**PLANNING COMMISSION**  
**Tuesday, December 11, 2018**  
265 Strand Street, St. Helens, OR 97051  
[www.ci.st-helens.or.us](http://www.ci.st-helens.or.us)

**CITY OF ST. HELENS PLANNING DEPARTMENT  
STAFF REPORT  
Conditional Use Permit CUP.4.18**

**DATE:** December 4, 2018  
**TO:** Planning Commission  
**FROM:** Jacob A. Graichen, AICP, City Planner

| SHEET ID<br><b>C-004</b>   |

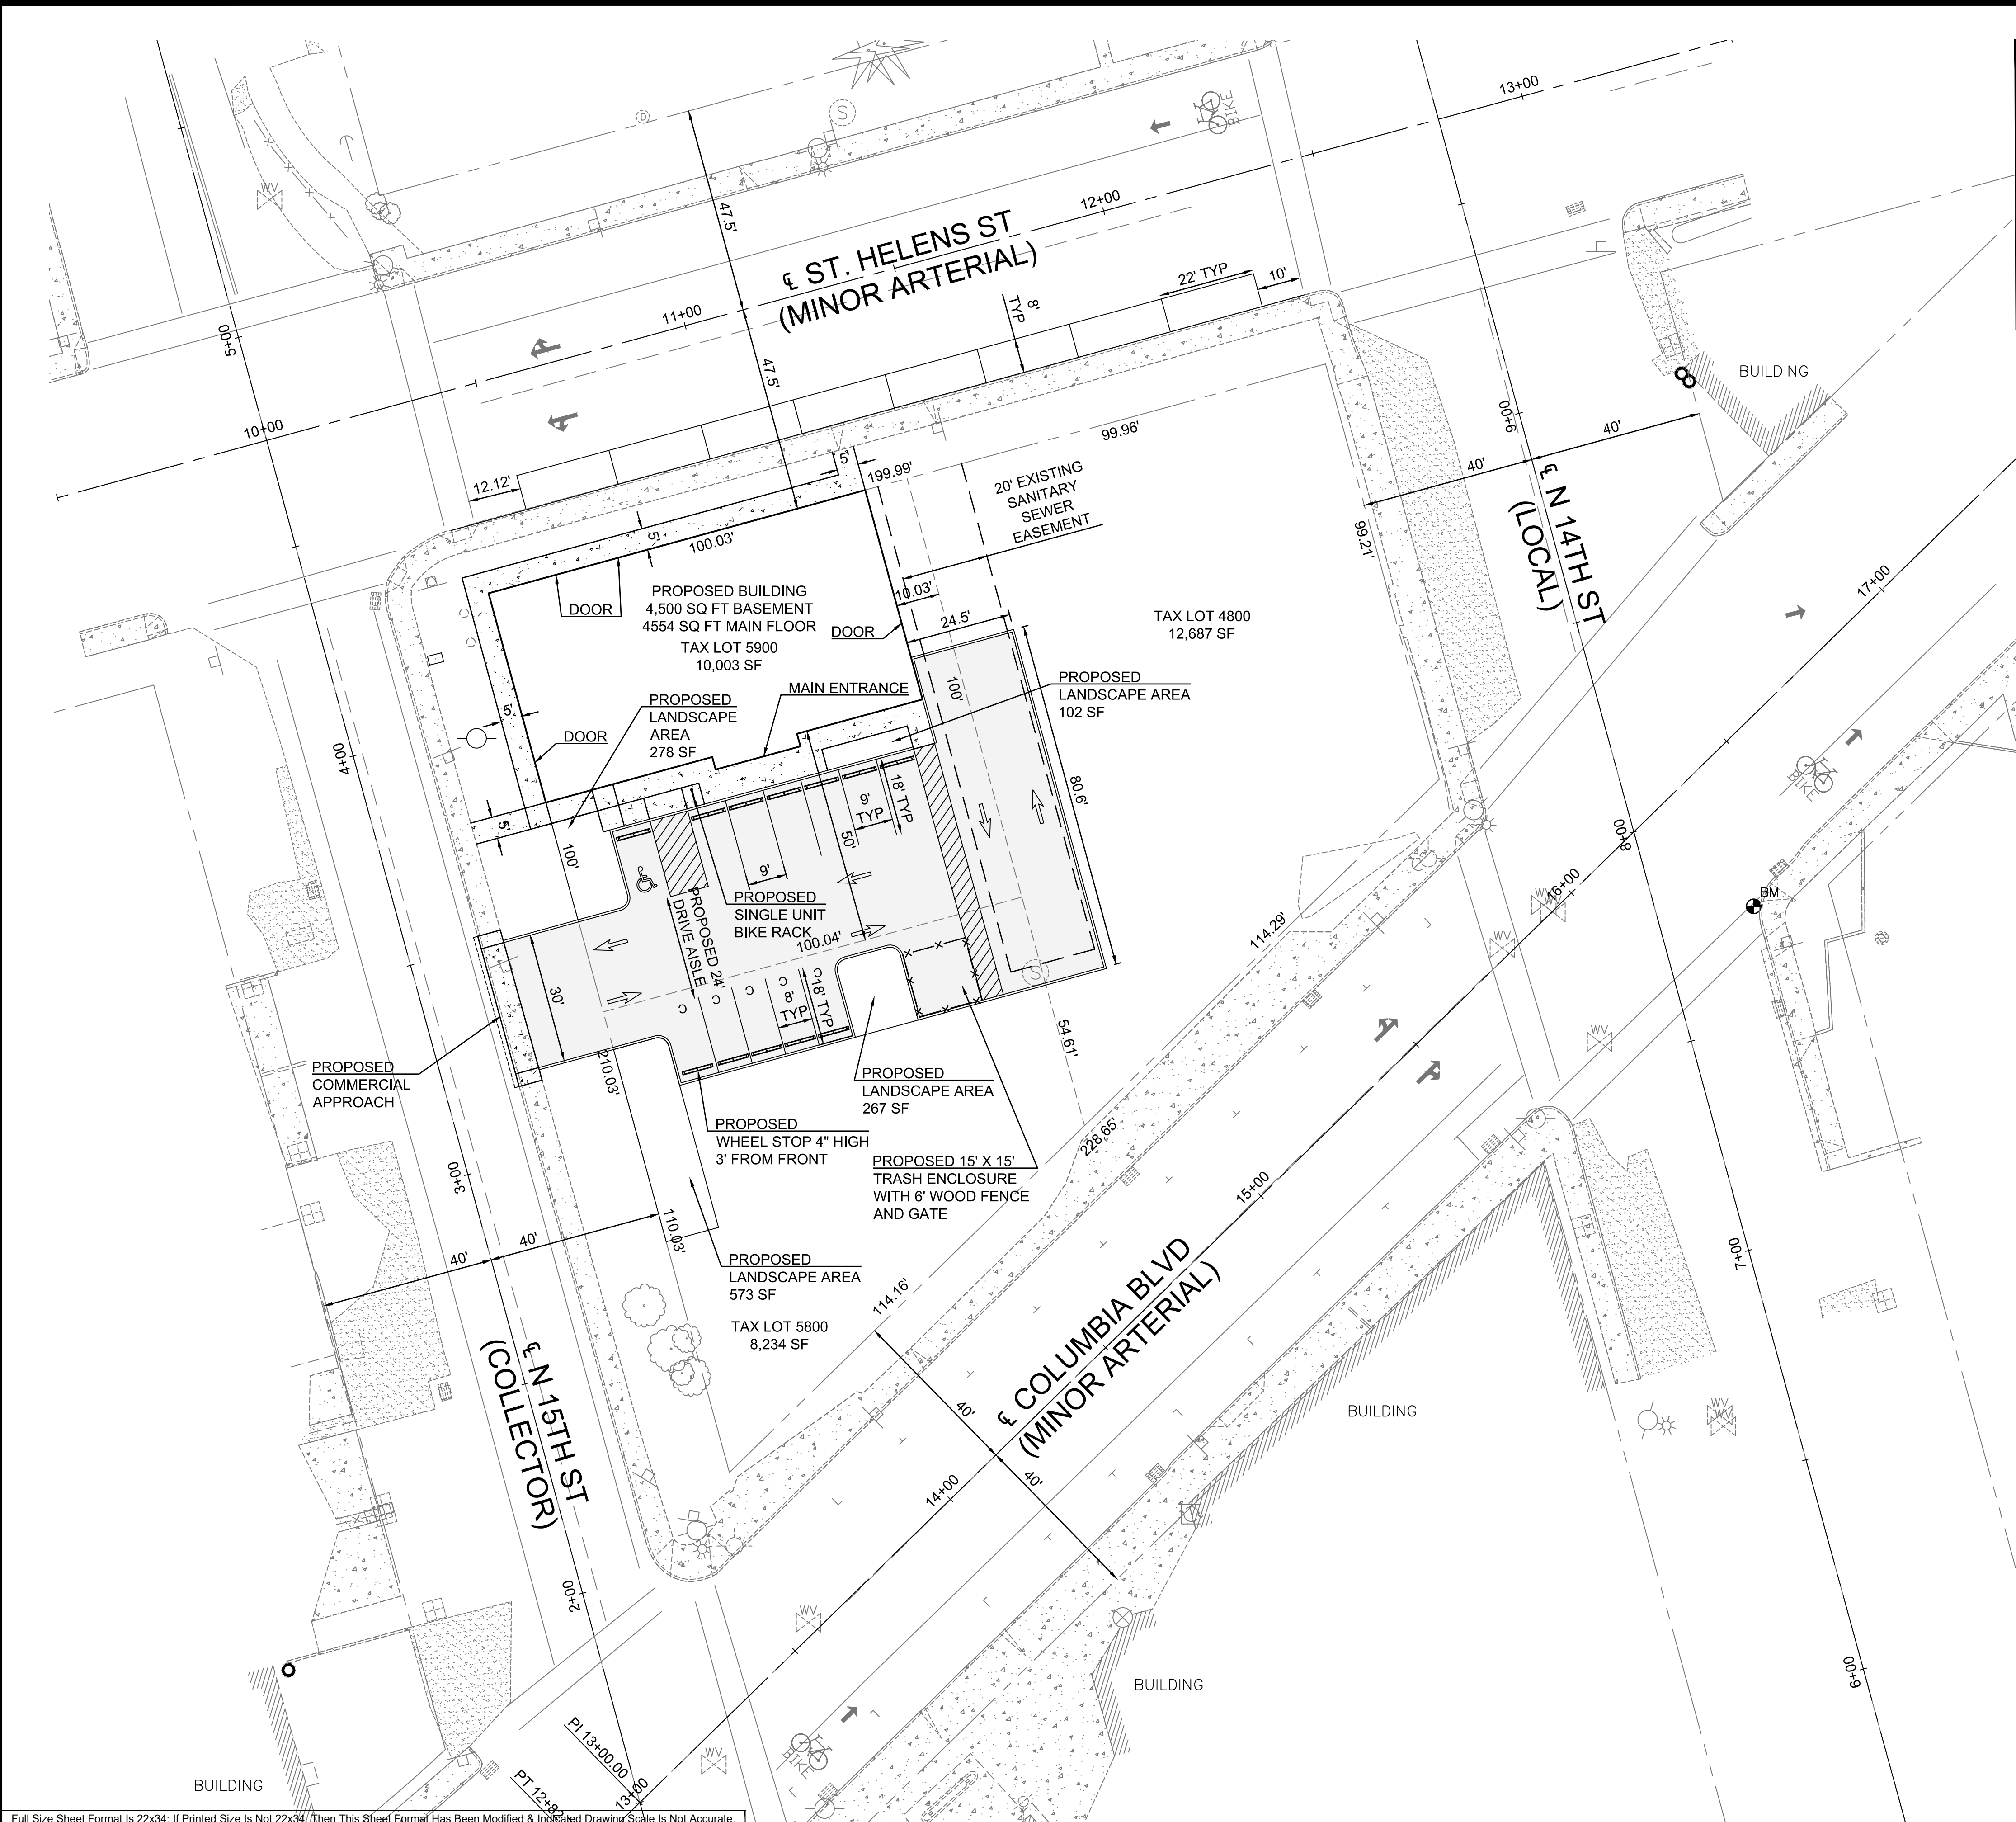
The plans show this. However, there is a door shown on the east side of the building to “nowhere” on the plans. Walkway required here too.

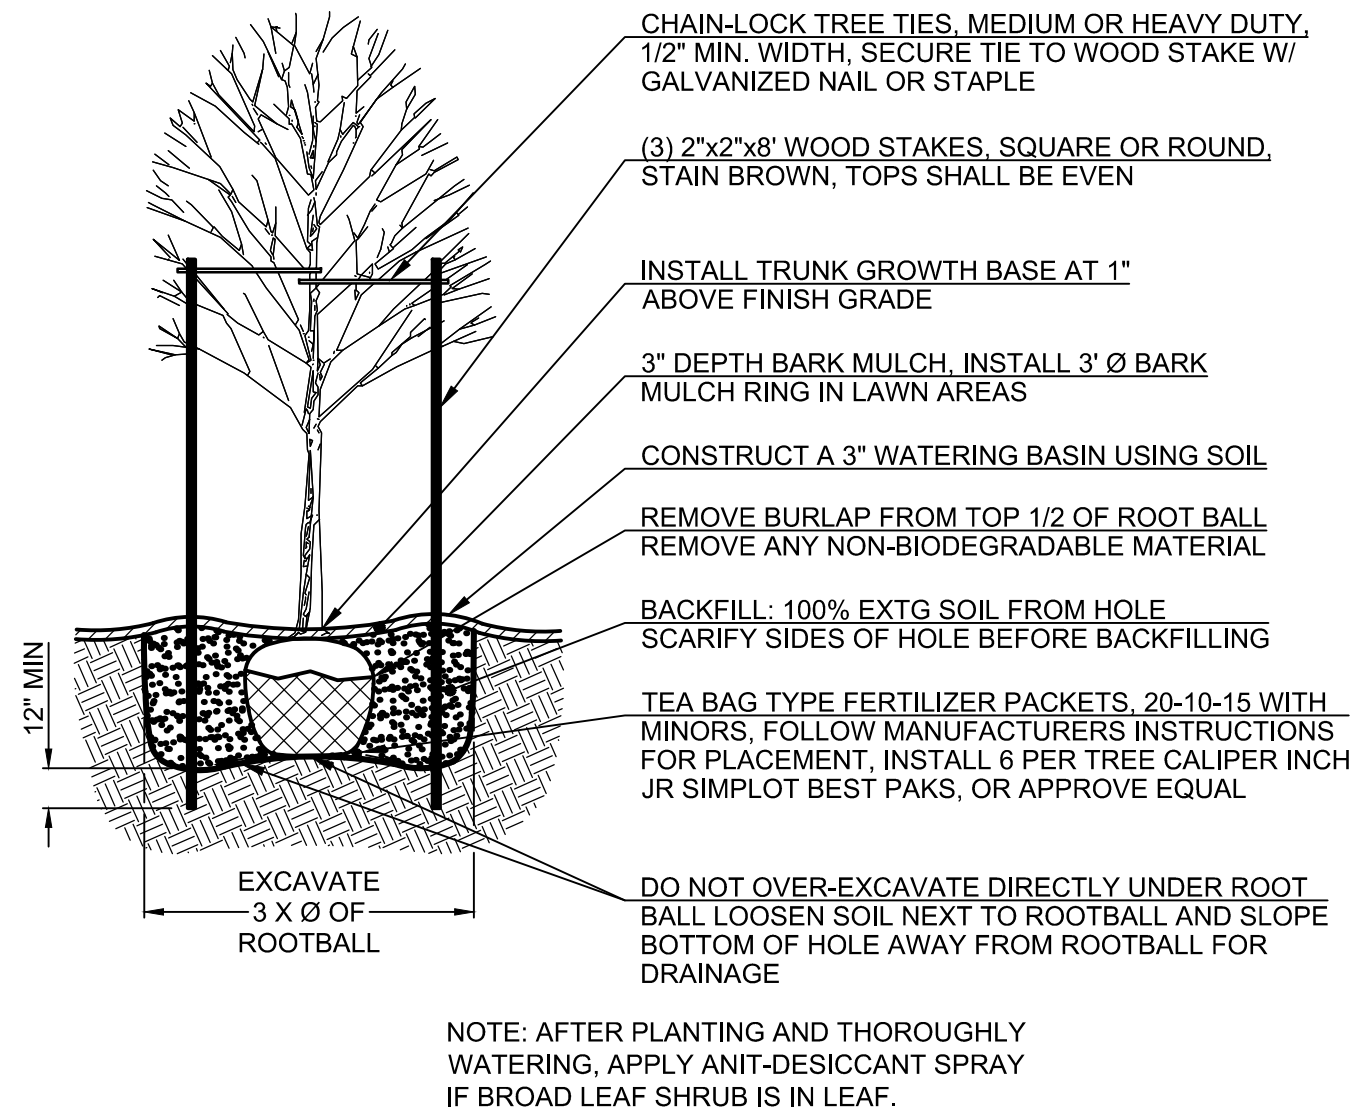
All trees noted on landscape plan are “small” trees. There is an inadequate amount of these trees shown. Also, note that the trees are shown behind the existing sidewalk, assuming frontage improvements are not required to be reconstructed.

balance of low lying and vertical shrubbery and trees. Landscape plan shows some of this, but doesn't include all sides.

- A. Landscape plans per the Development Code and to address the shortcomings of the preliminary landscape plans as described herein. Plan shall include at least 30 new trees.
